# SERVICE BULLETIN

M-1103

## REVISED TRANSMISSION VENT HOSE ROUTING FOR 2000 MODEL SPORTSTERS

Figure 2. Battery Tray Removed

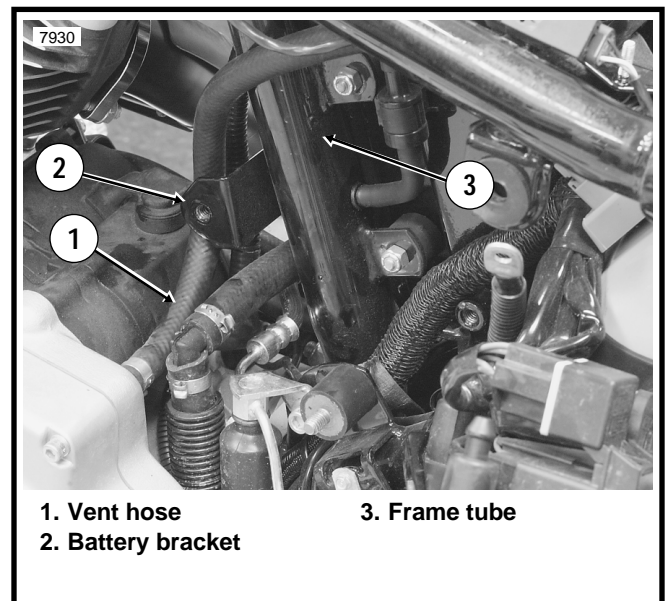
7. See Figure 3. Remove T-stud clip attaching vent hose to inboard side of oil tank. (Skip this step if clip was removed in step 2 above.)
8. See Figure 2. Reroute vent hose (1) behind front battery bracket (2), up and outboard of frame tube (3).
9. See Figure 4. Install battery tray and connect harness connector (3) on bank angle sensor.
10. See Figure 4. Locate positive battery cable (1) between vent hose and oil feed/drain hose. Loosely install cable strap, Part No. 10006, (2) to locate vent hose on battery tray as shown.
11. See Figure 3. From battery tray route vent hose to inboard side of oil tank and secure with T-stud clip.
12. See Figure 1. Install harness anchor (2) in battery tray hole.
13. Refer to Section 7 of the XLH Service Manual, install battery and seat.

**Figure 5. Lubricant Level With Motorcycle Upright**

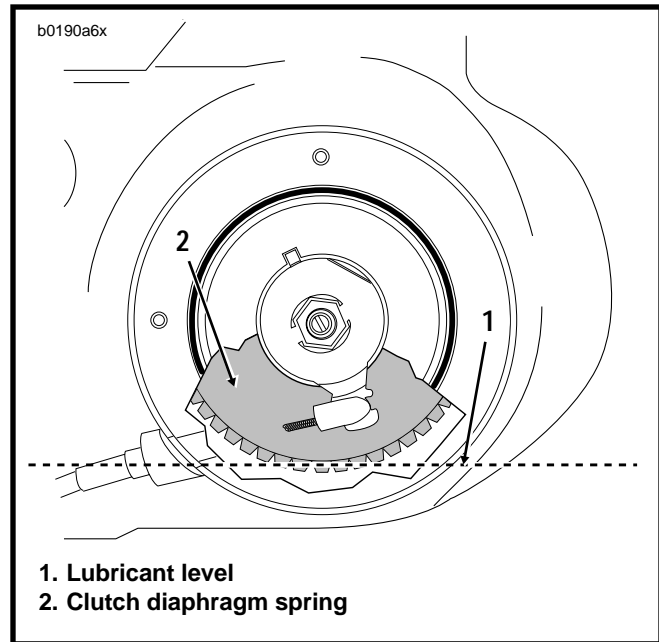
14. See Figure 5. Refer to Section 6 of the XLH Service Manual and remove clutch inspection cover. Check that transmission/chaincase is not overfilled. Drain to proper level if necessary.

**When performing regular scheduled transmission fluid changes, only fill to the level shown in Figure 5. Do not simply add 32 oz. as there may be fluid retained in transmission cavity which could then cause an overfilled condition.**
